Your reference: DEV2012/403/10

**RE: FLAGSTONE CITY – STAGE 2D & STAGE 5I: CHANGE APPLICATION
 FURTHER ISSUES RESPONSE (TRAFFIC)**

A change application was lodged with Economic Development Queensland (EDQ) regarding proposed modifications to the Flagstone City Stage 2D and 5I approvals (DEV2012/403/10). A Further Issues Letter was issued by EDQ on the 5th November 2020 regarding the change application to which this letter seeks to address the traffic and transport related items raised.

Project		Flagstone City	
Title		Concept Plan Flagstone City Stage 2D & SI Road 1 & Roundabout Design

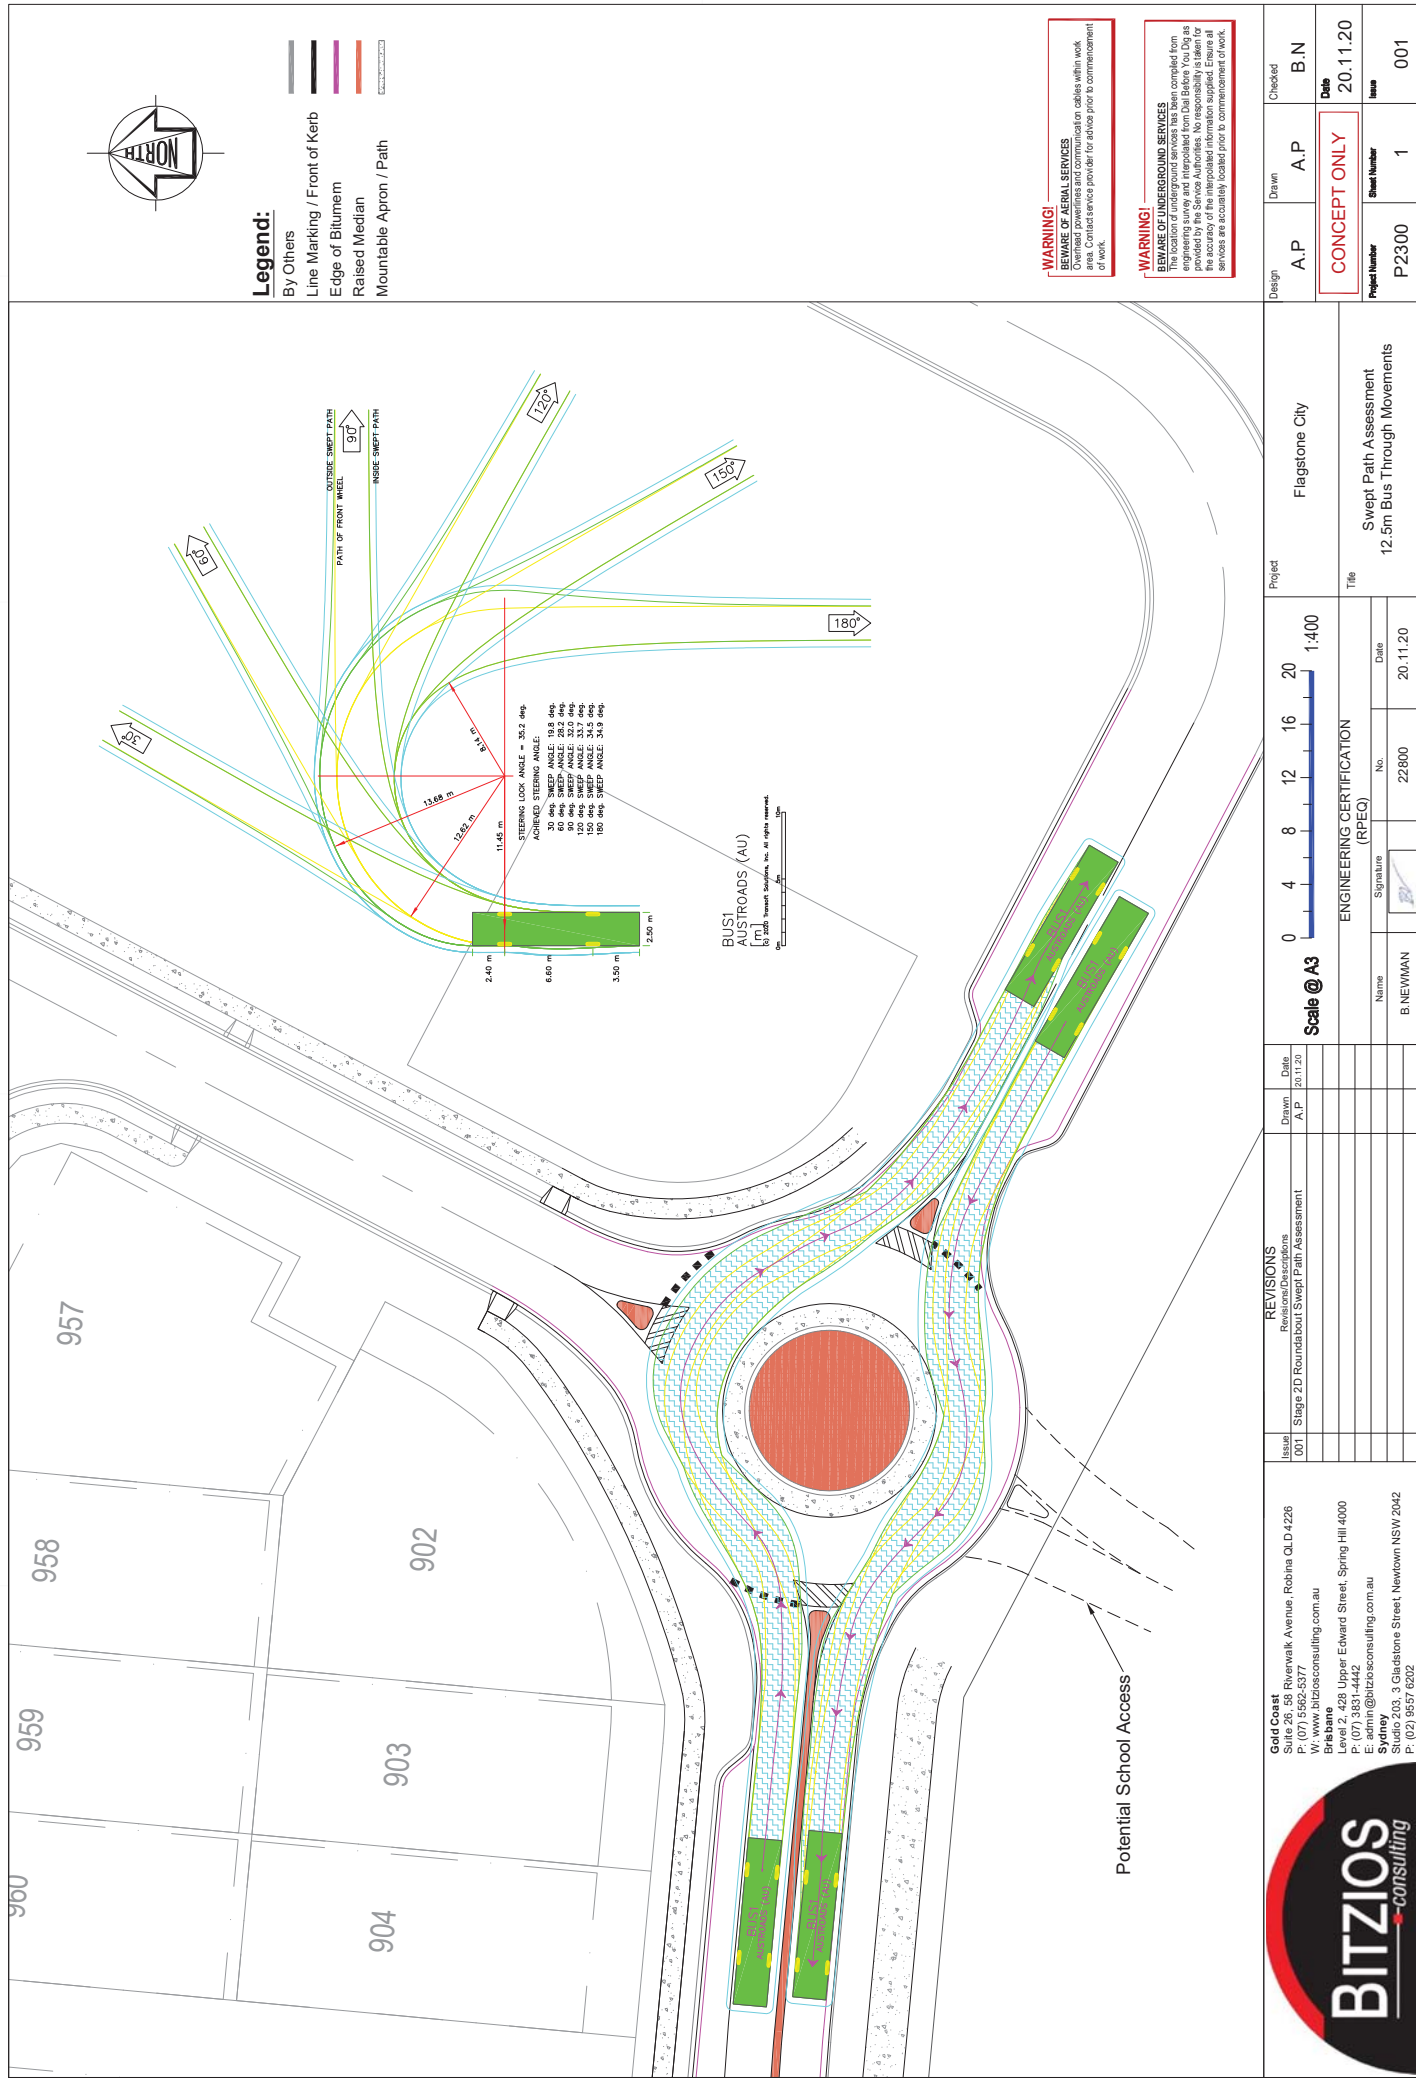
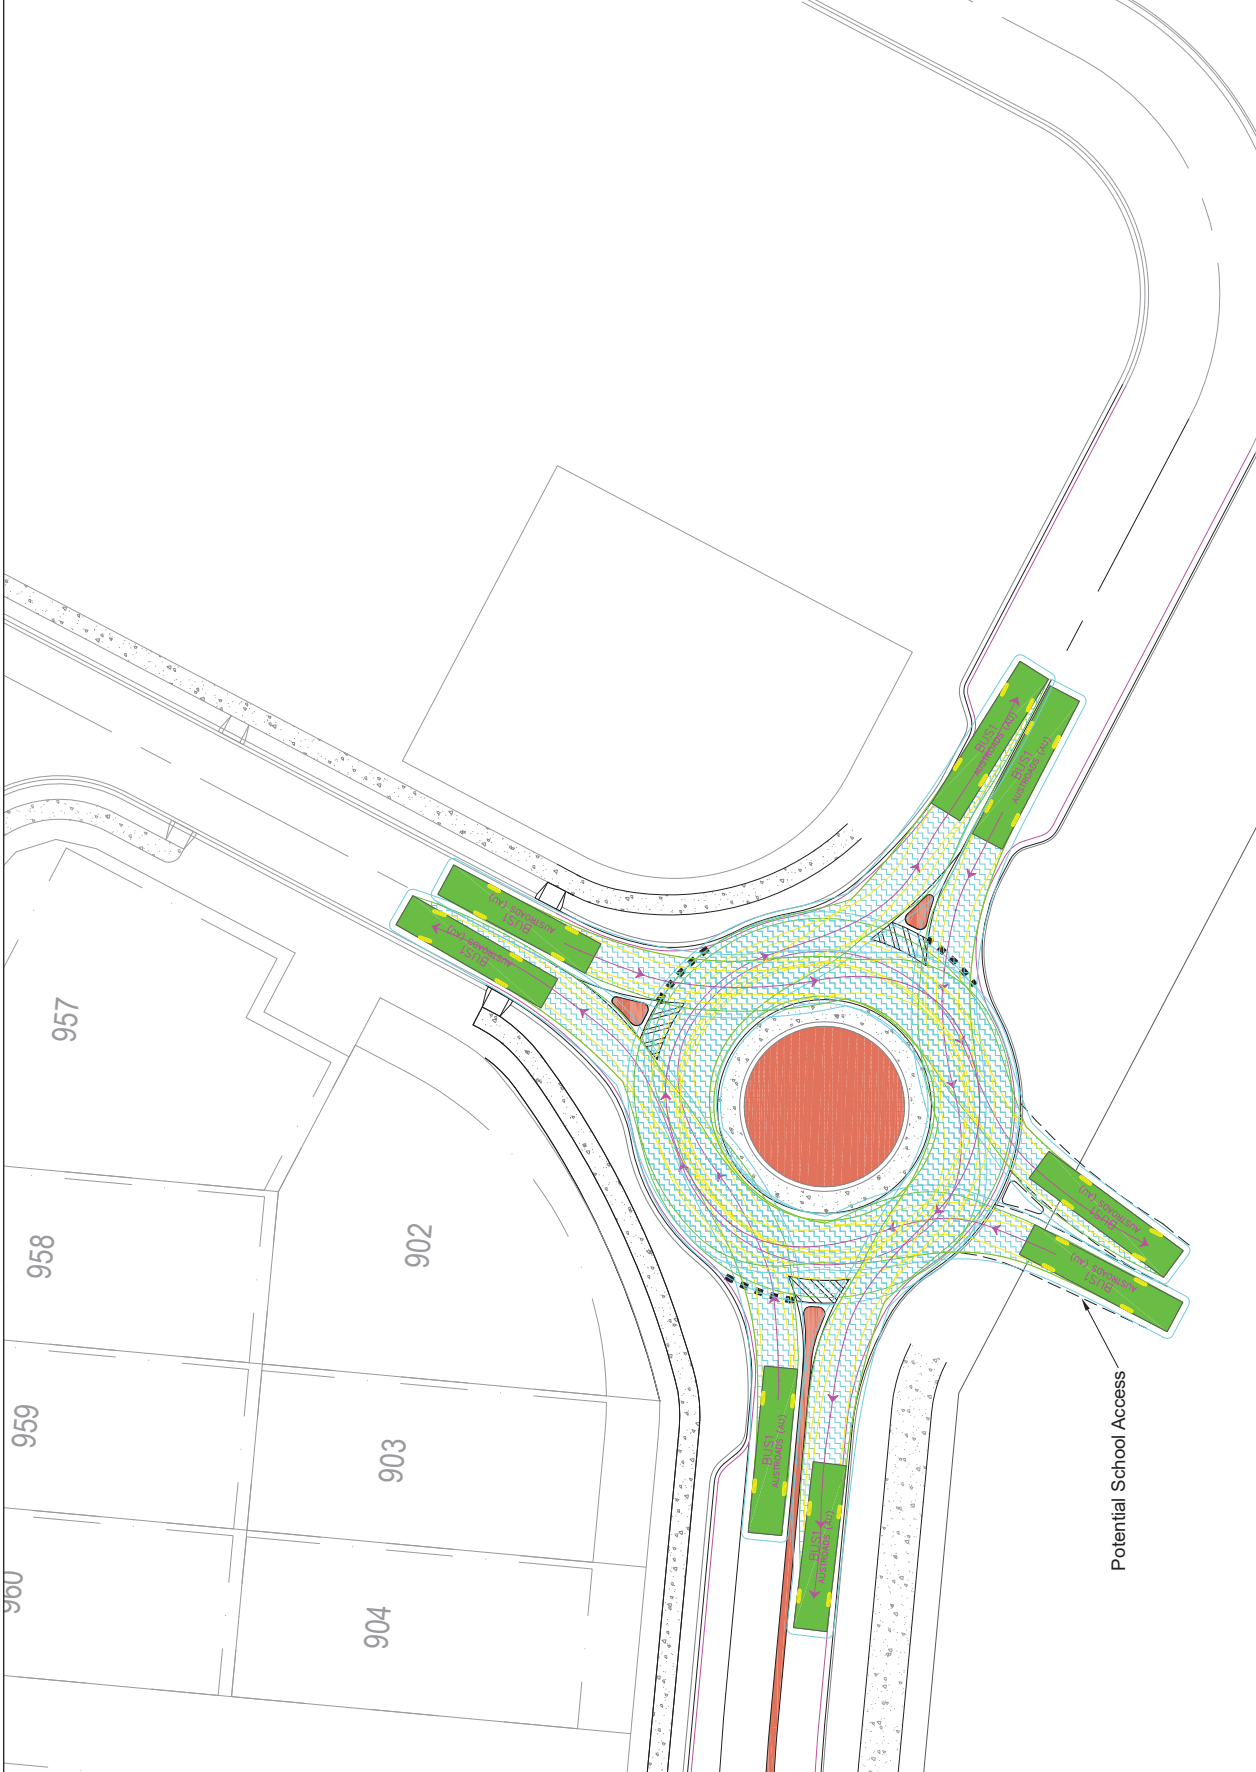
Provide a revised RPEQ certified design for the proposed roundabout in Stage 2Dii which demonstrates compliance with the following for single unit rigid buses of 12.5m (urban bus) and 14.5m in length (school bus):

To prevent right hand turn movements into and out of the childcare lot (Stage 2Di) from Road 1 the submitted traffic engineering memo suggests the utilisation of a double centre line, signage, and a left in/left out configured crossover. These prevention measures are considered insufficient to discourage right hand turning movements into and out of the childcare centre lot given the sizable residential catchment across the various Stage 2 residential zones to the north/ north east of the site.

Submit an amended traffic engineering memo that provides for a median along the full length of Road 1 from the Flagstonian Drive intersection up to the proposed roundabout.

EDQ is not satisfied that the submitted traffic engineering memo has considered in the analysis school peak traffic volumes, including bus movements, or pedestrian movement along the Road 1 footpath, which will have the effect of forcing vehicles to give way and queue on Road 1. Therefore, there is a risk of vehicles queuing on Road 1 back into the intersection with Flagstonian Drive.

Submit an amended traffic engineering memo that provides for a dedicated left turn slot from Road 1 into the childcare centre lot (Stage 2Di).

The submitted traffic engineering memo relies on the construction of the Road 1 roundabout to facilitate turning movements for vehicles exiting the Display Village. However, the proposed sub staging defers the construction of the roundabout until after the establishment of the Display Village. Therefore it is considered that the only way to facilitate all turning movements for vehicles exiting the Display Village before the construction of the roundabout on Road 1 will be to extend Flagstonian Drive beyond the Road 1 intersection (an appropriate distance) and construct a temporary vehicle turn around within the future Flagstonian Drive road reserve.

The revised concept design for the roundabout is provided in **Attachment B**.

As shown in **Attachment B**, a narrow median is proposed along the length of Road 1 from Flagstonian Drive to the proposed roundabout. This narrow median width is proposed noting the constraints of the approved 'Neighbourhood Connector' road reserve and accords with Logan City Council provisions. Furthermore, a wider median facilitating pedestrian storage may encourage pedestrians to cross midblock at this location which is not desirable.

The concept plans has been amended to include a short auxiliary left-turn (AUL(s)) lane for vehicles entering the childcare centre access from Road 1.

- **Storage Length:** 10m
- **Taper Length:** 30m
- **Lane Width:** 3m

An interim extension of Flagstonian Drive is proposed north of Road 1 to facilitate turnarounds in the short-term. This extension will include a temporary turnaround head (cul-de-sac) allowing display village egress traffic to turn around in the event that the display village is established prior to the construction of the proposed roundabout. Car parking may also be accommodated on the western side of the Flagstonian Drive temporary extension subject to ongoing considerations.

The concept plan in Attachment B shows an indicative temporary turnaround within the Flagstonian Drive road reserve capable of accommodating a 14.5m bus turnaround (as shown in Attachment C swept paths). This extension concept is indicative only and will be subject to more detailed design in the near future considering other relevant factors.
